DESIGN SPECIFICATION

NCC 2019 VOLUME 1 (AMDT 1) & ACCESSIBILITY

Macquarie Health Corporation

Longueville Private Hospital

Figure 2.1.2 – proposed ground floor

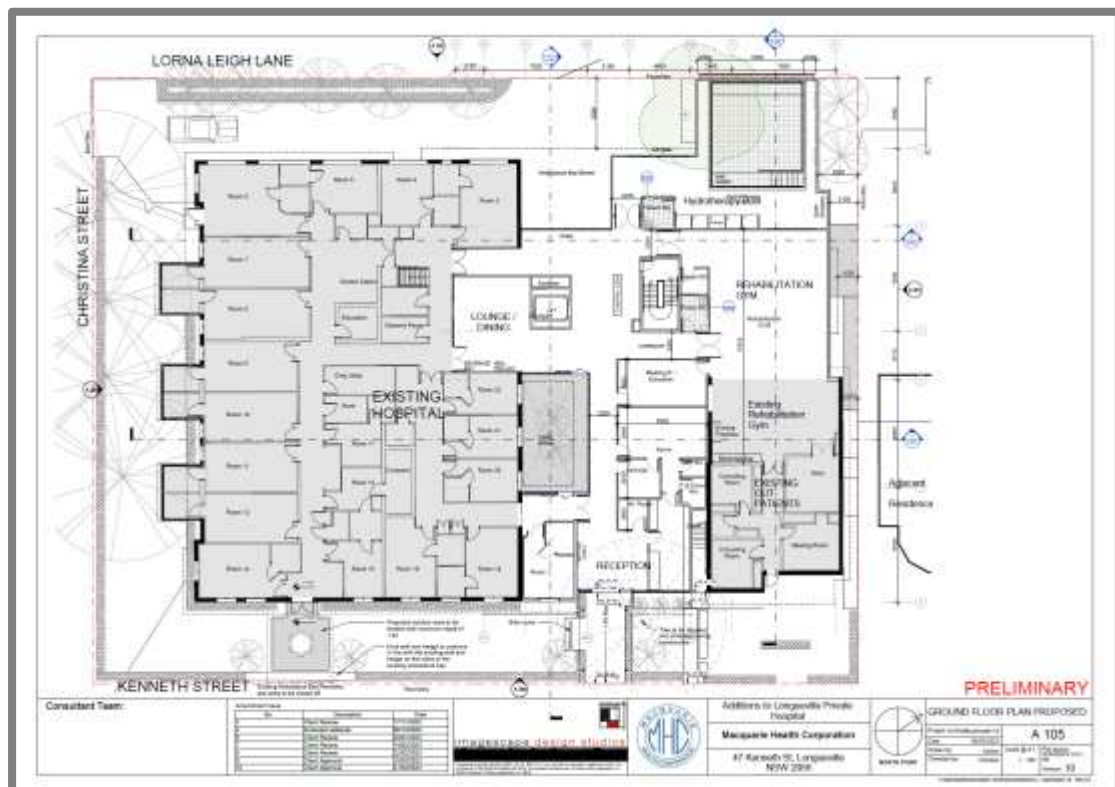
The line of firewall separation through the ground floor is intended to wrap around the open courtyard between compartments G1 and G2.

The various glazed openings in the perimeter of the open courtyard represent openings in the external walls of different fire compartments that need be fitted with Clause C3.4 compliant opening protectives.

- (a) The dead-end travel distance in the ground floor hydrotherapy pool area exceeds 12-metres.
- (b) Clarification is required as to the continued availability of egress out of the building and to Kenneth Street via the existing ambulance entry, as plan A105 appears to indicate that such shall be closed off.
- (c) Areas shall exist within the first floor that have a dead-end travel distance exceeding 12-metres to an exit or point of choice between exits.

- (a) The proposed doorway opening in the ground floor reception area, between the office and the IT rooms (separating the reception and admin), is not provided with 530-mm latch side circulation.

This will necessitate either modification of the design or the installation of a all-mounted accessible door handle device on both sides of the opening.

- (b) One of the change rooms within the ground floor pool area need be designed to accommodate a wheelchair user, or the accessible toilet be designated for such a purpose.
